WATERLOO METRO QUARTER CENTRAL PRECINCT

SSD-10439 - RESPONSE TO SUBMISSIONS

SOLAR ACCESS

WEST APARTMENT

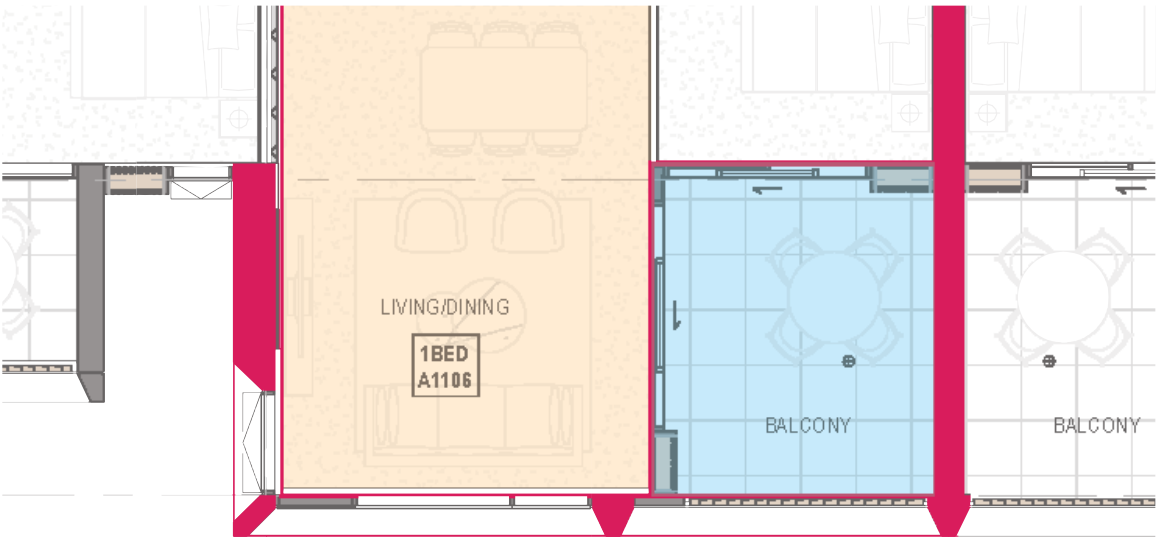
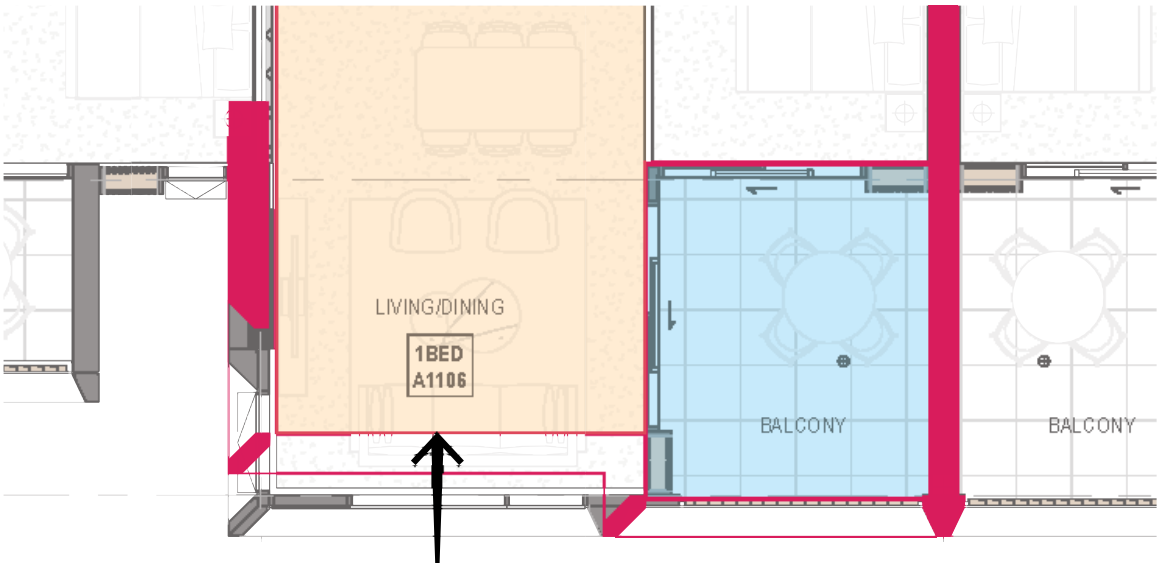
_Opportunity to improve the solar compliance of the POS while considering architectural expression, internal layout and functionality.

Proposed Scheme - Stepped Facade

Setback living room 700mm to allow direct solar into private open space

The proposed scheme improves the solar access to the POS of the west 1 bedroom apartment. Both living room and POS has access to a minimum of 1sqm of solar for 1 hour and 50mins between 9:00am and 3:00pm mid winter.

An additional 14 apartments between level 6 and level 19 achieves the intent of ADG to maximise solar access to both living room and POS between 9:00am and 3:00pm.

HIGHRISE EAST APARTMENT

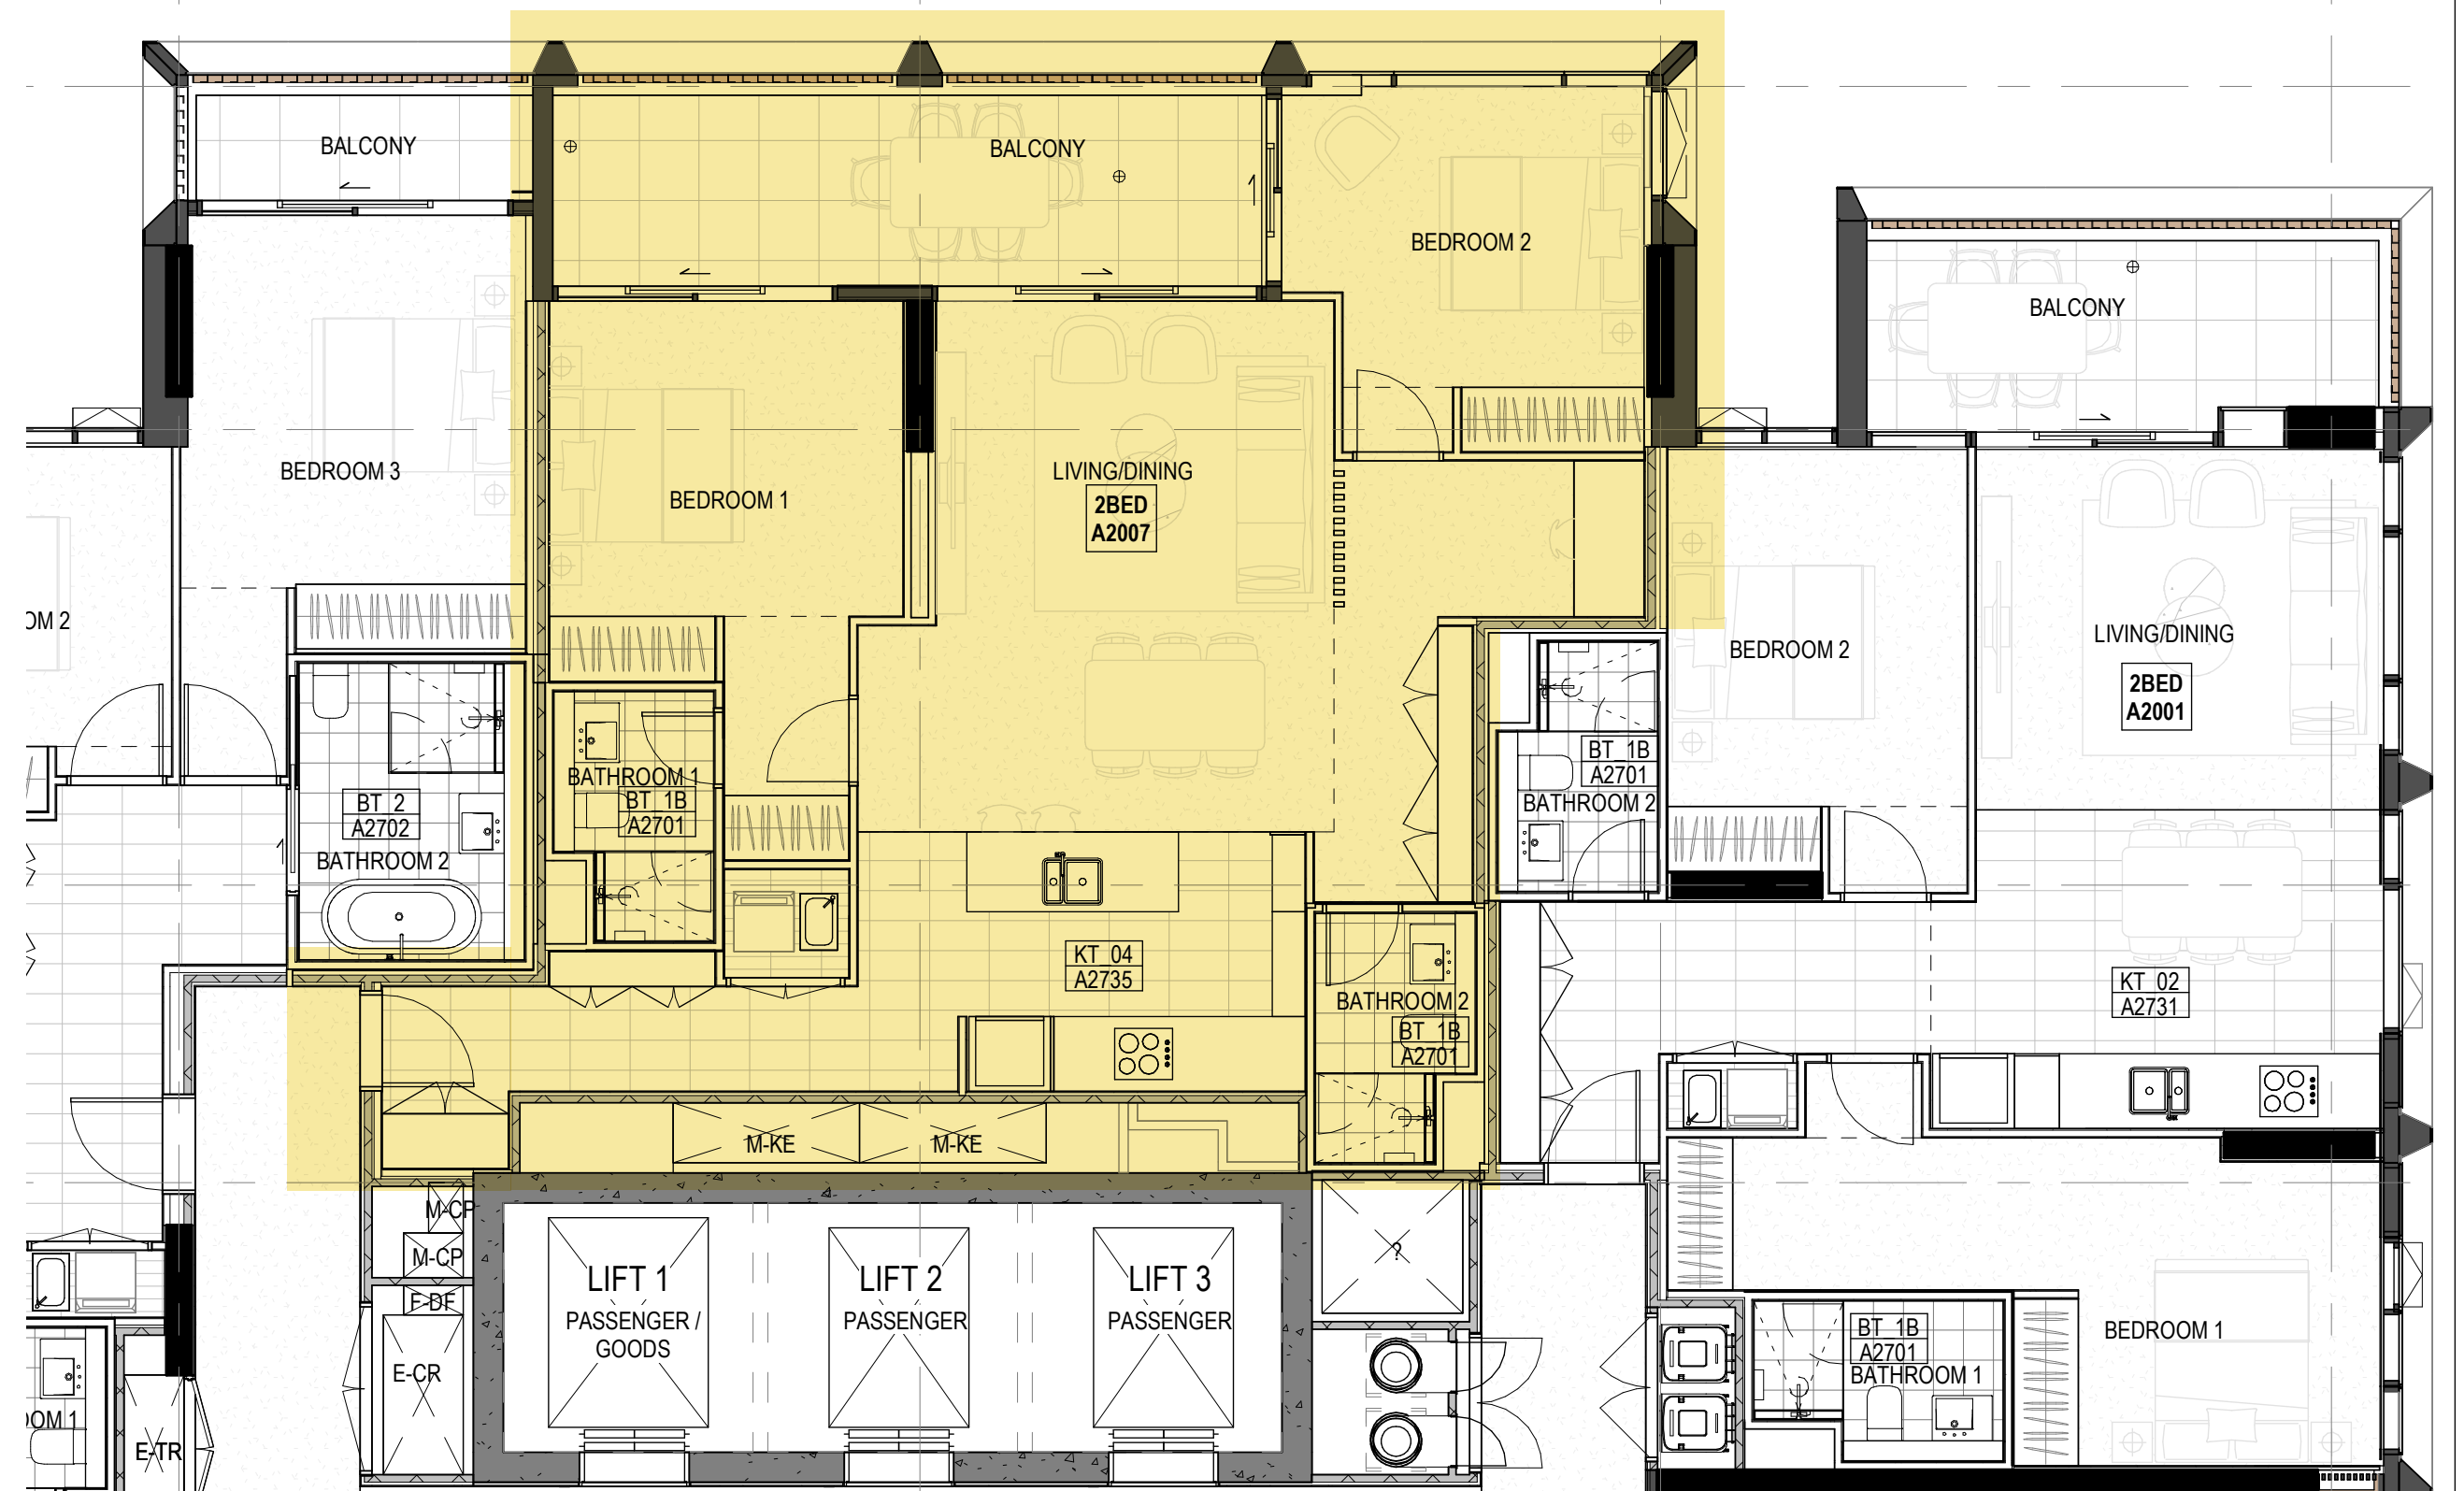
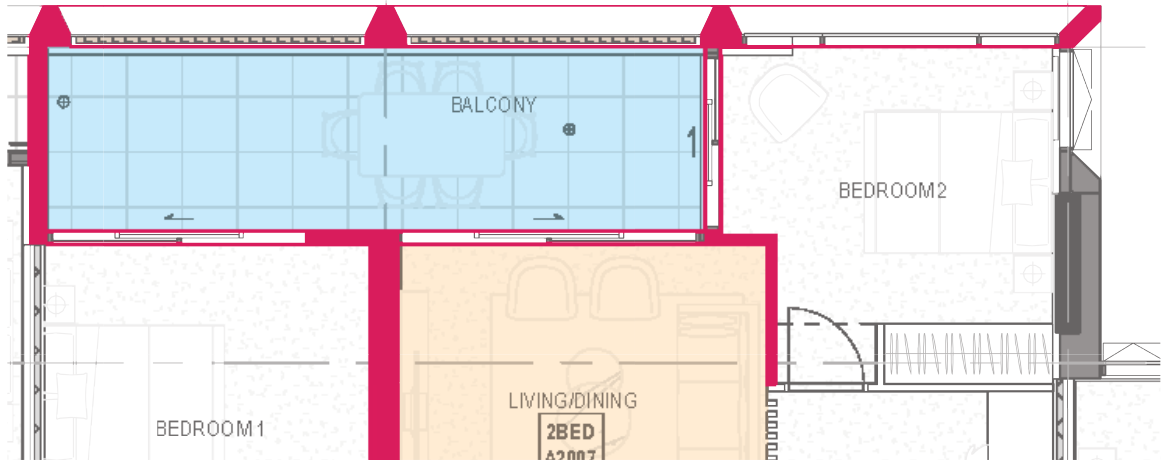
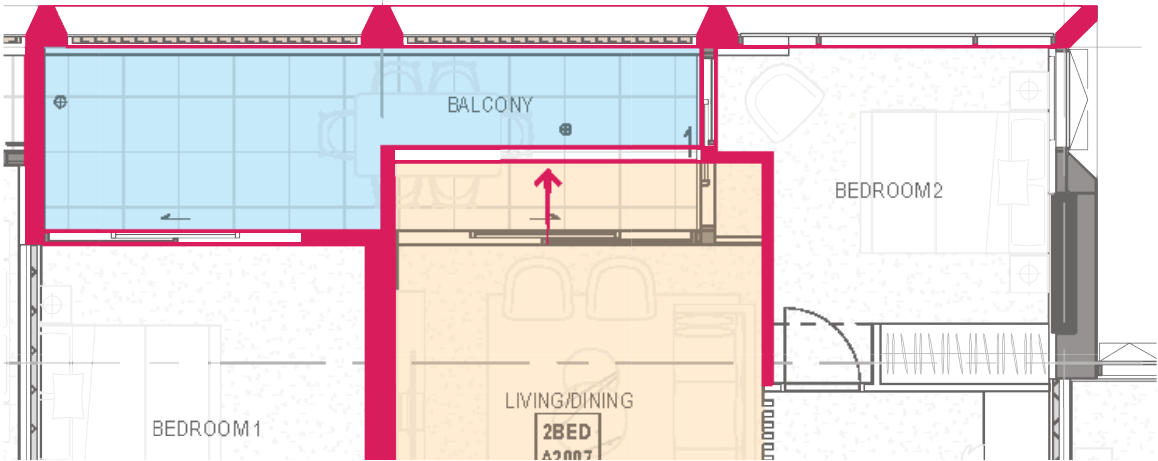
_Opportunity to improve the solar compliance of the living room while considering balcony area and functionality.

Proposed Scheme - Stepped Facade

_Push out living room facade to allow direct solar into living room

The proposed scheme allows the living room of the level 20 and 21 east facing 2 bedroom apartments to have access to a minimum of 2 hours solar access between 9:00am and 3:00pm mid winter, resulting in an additional 2 compliant apartments.

An additional 2 apartments on level 20 and 21 achieve a minimum of 2 hours solar access to both living room and POS between 9:00am and 3:00pm.

HIGHRISE WEST APARTMENT

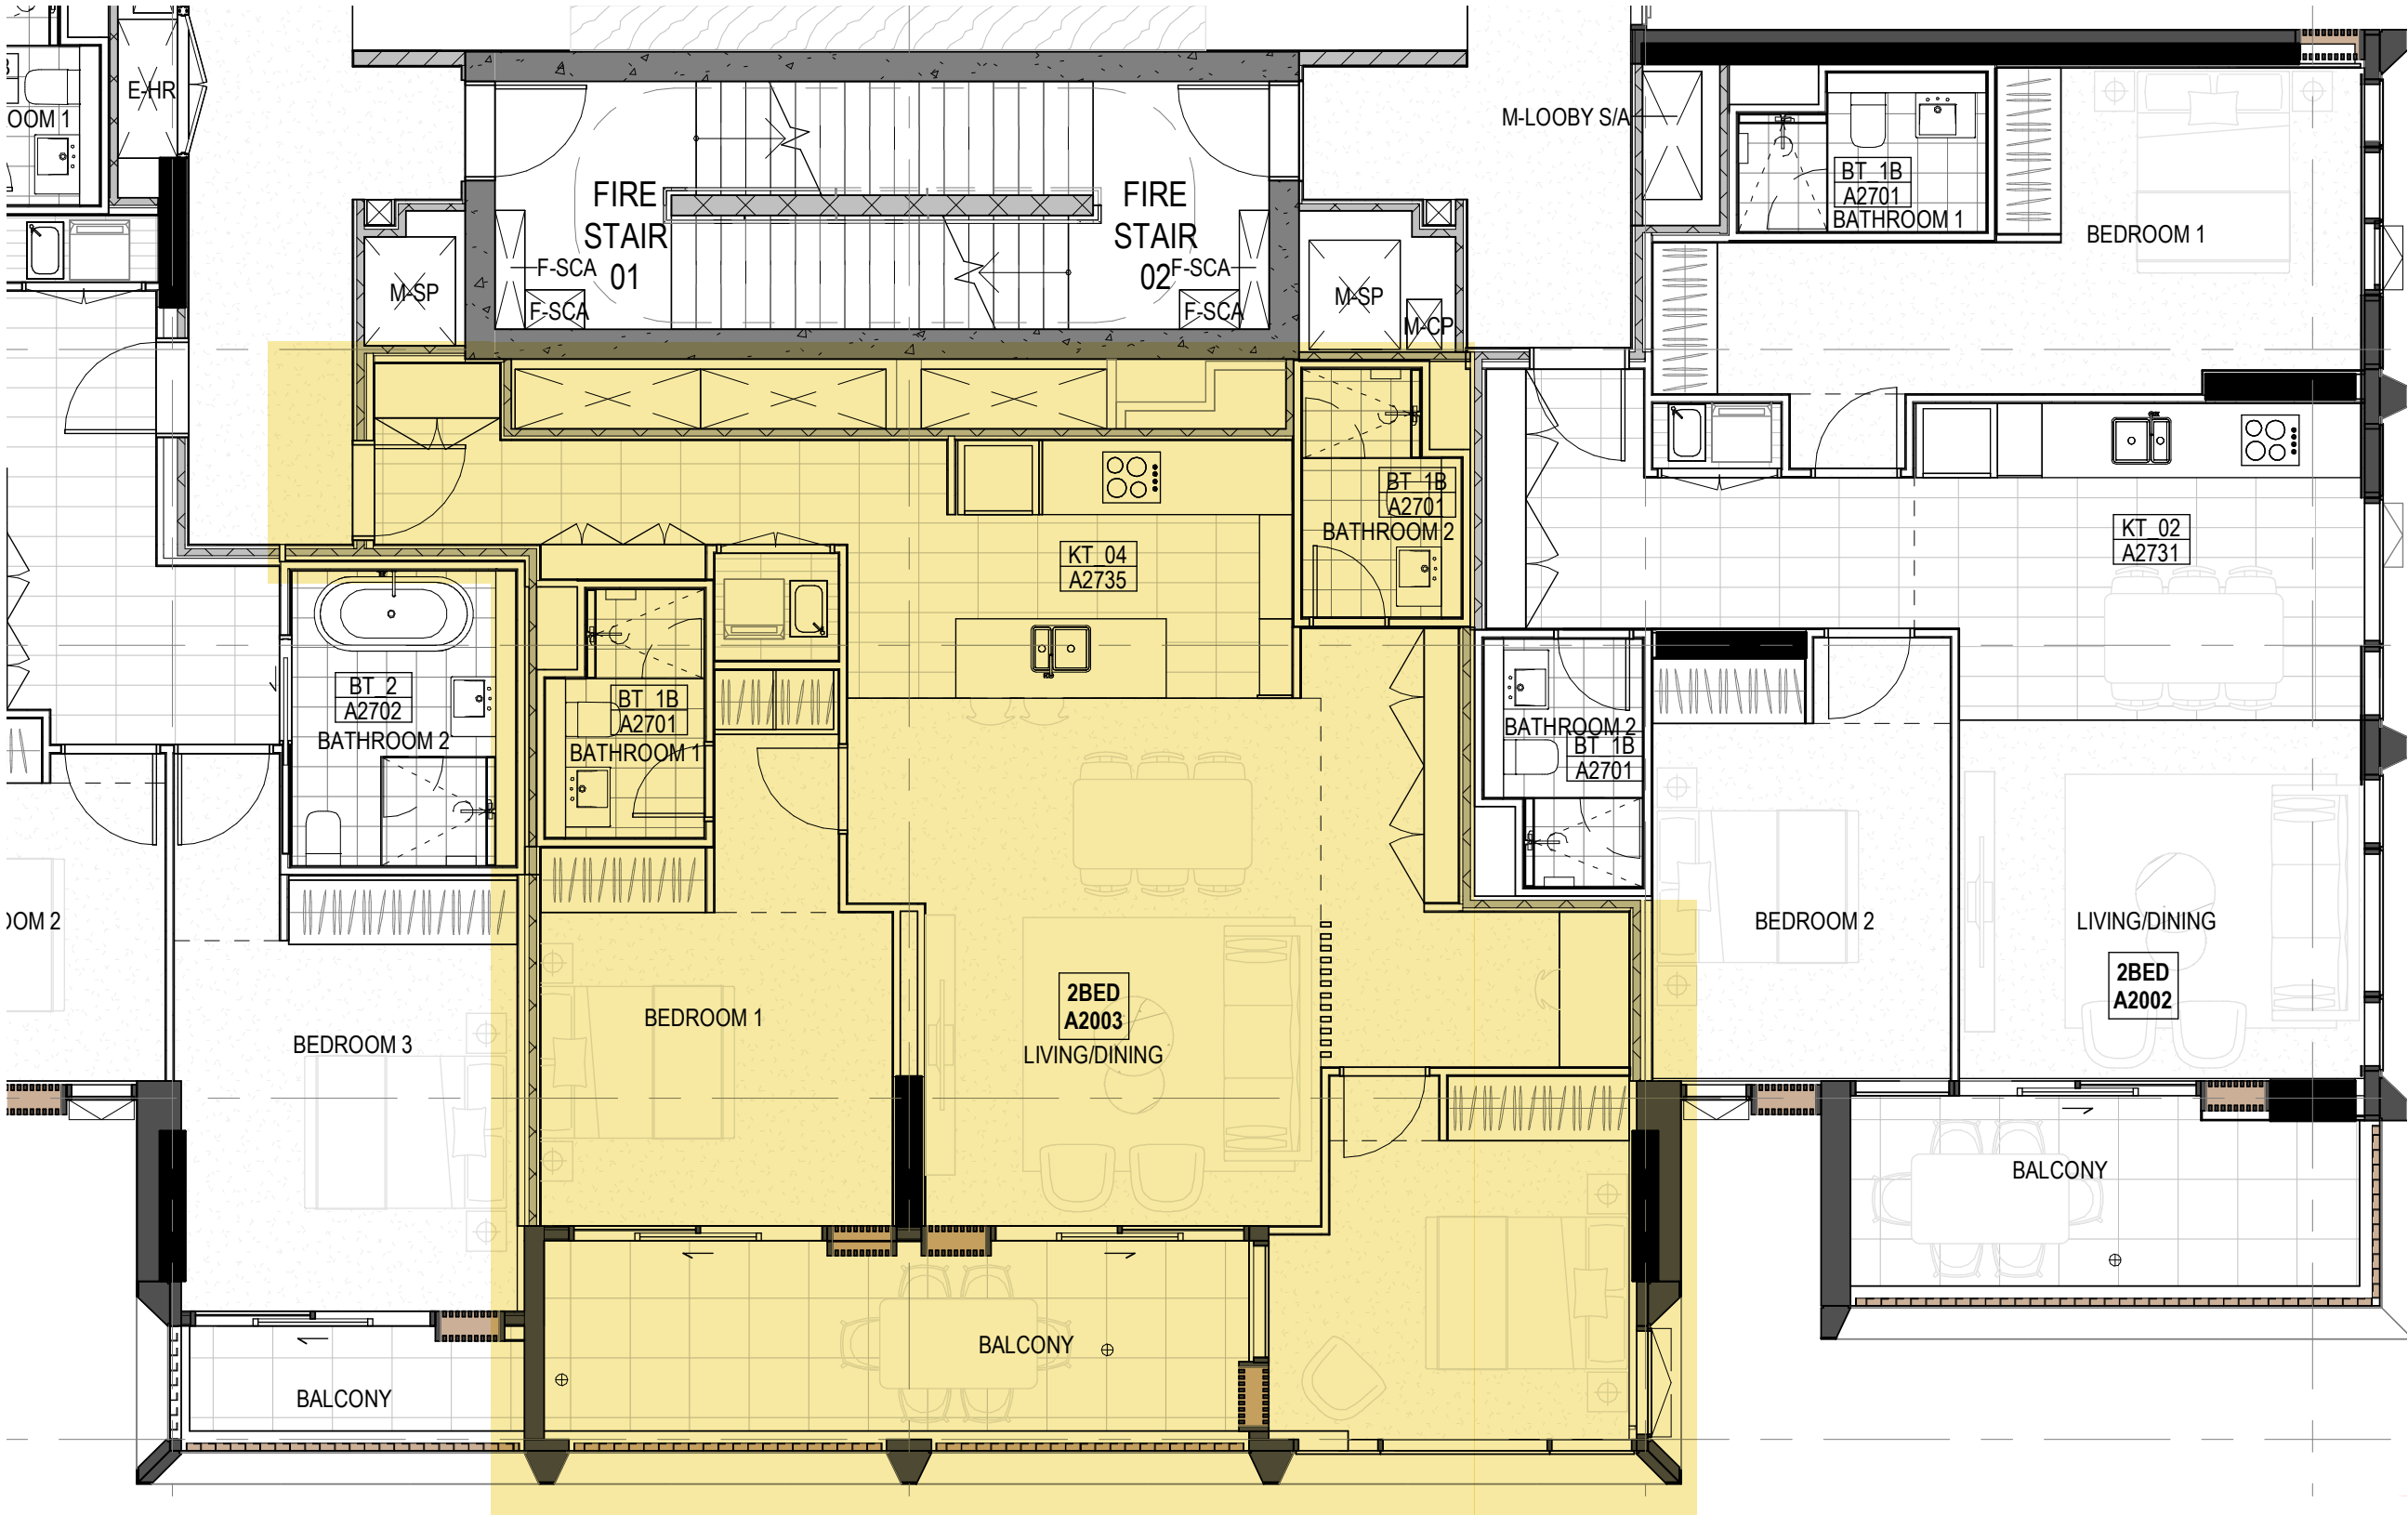
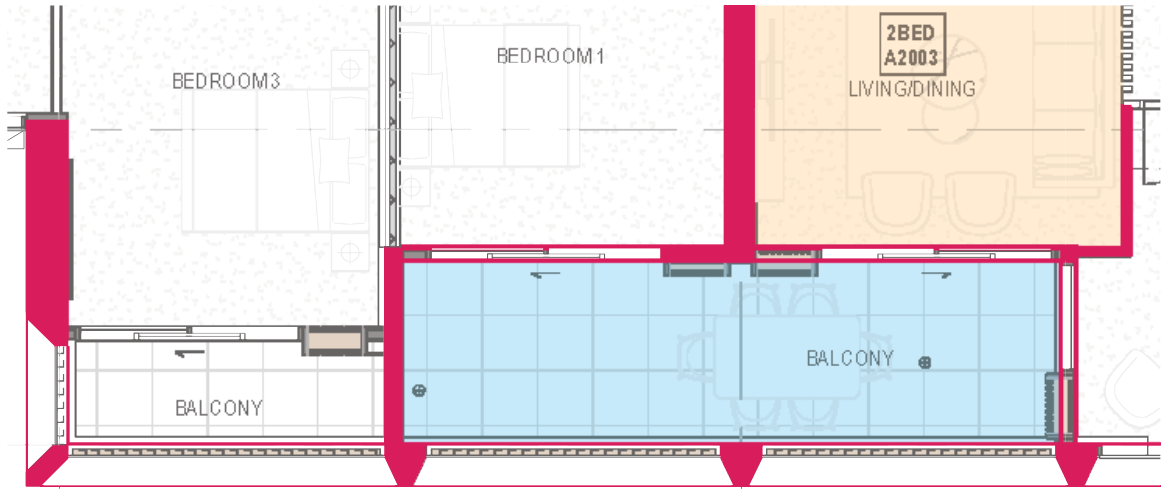
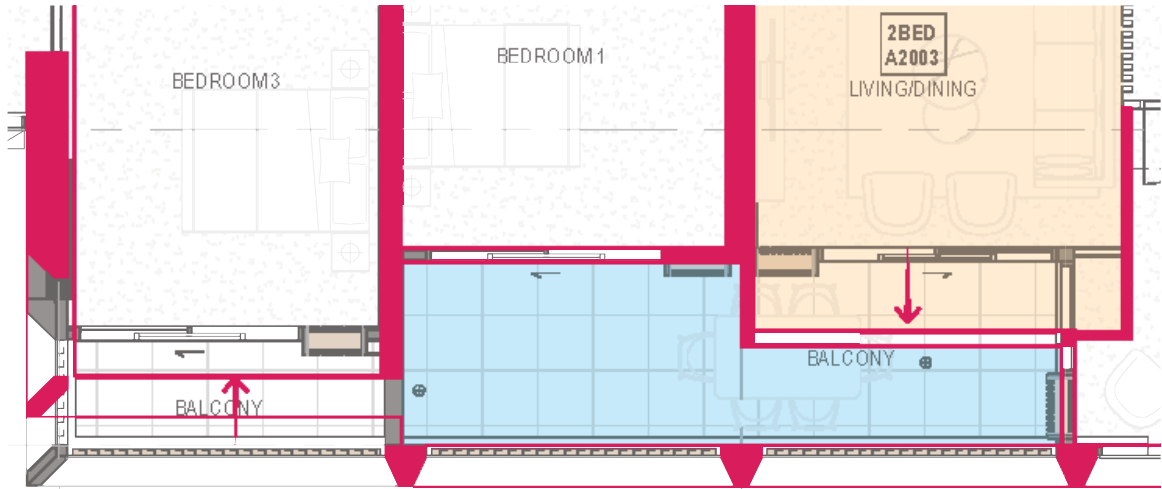
By applying the same change to the highrise west apartment, it will improve the solar access to both the living room and POS.

Proposed Scheme - Stepped Facade

_Push out living room facade to allow direct solar into living room

The proposed scheme improves the solar access to the living room of the high rise west apartment by 30 mins, and POS by 45 mins compared to the DA massing.
